Permit Number: 030459

This is to certify that Morrill Street Associates/M. Brewer Electric & Plumbing
has permission to Construct a 140' x 60' Steel Building for Multi Tenants/Commercial
AT 57 Bell St Call 150 B001001

To: Dennis Paul Watson From: Mike Nugent
Fax: 303-904-4866 Date: May 19, 2003
Phone: 303-904-4837 Pages: 1
Re: Morrill St. Associates 57 Bell St. 150b001

PROJECT TITLE: M.R. BREWER FINE WOODWORKING - SITE DEVELOPMENT

SK-001

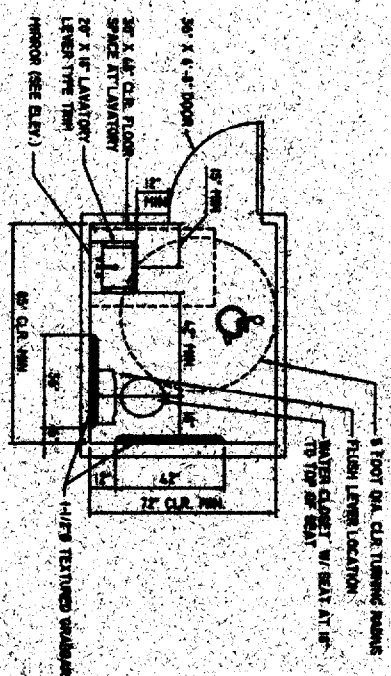
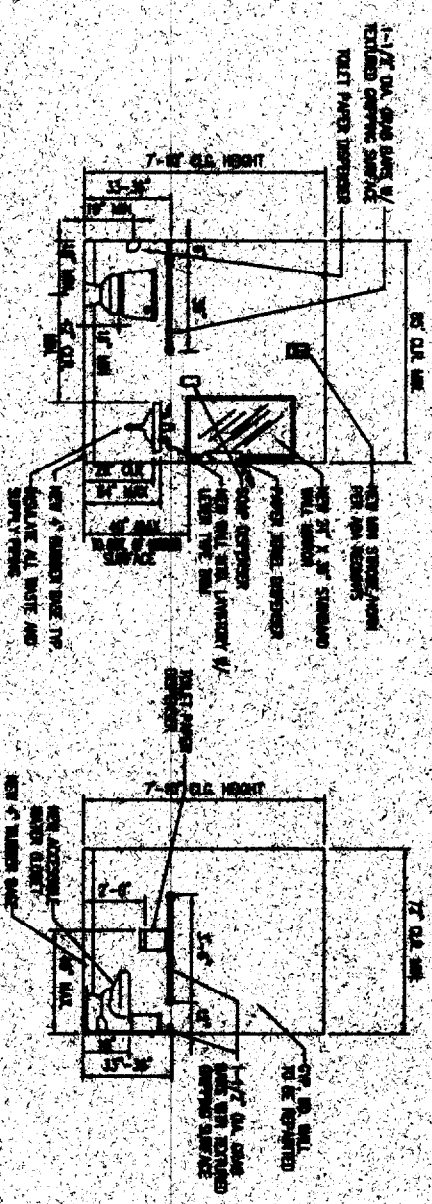
17. At least one unisex accessible restroom must be provided within the facility to meet the Americans with Disability and the Maine Human Rights act. If separate men's and women's restrooms are provided and so identified, then both restrooms must be fully accessible. See attached sketch.

- Provide rear wall accessible toilet grab bar at the water closet set no more than 6 inches from the side wall measured to the center of the grab bar return. See attached sketch.
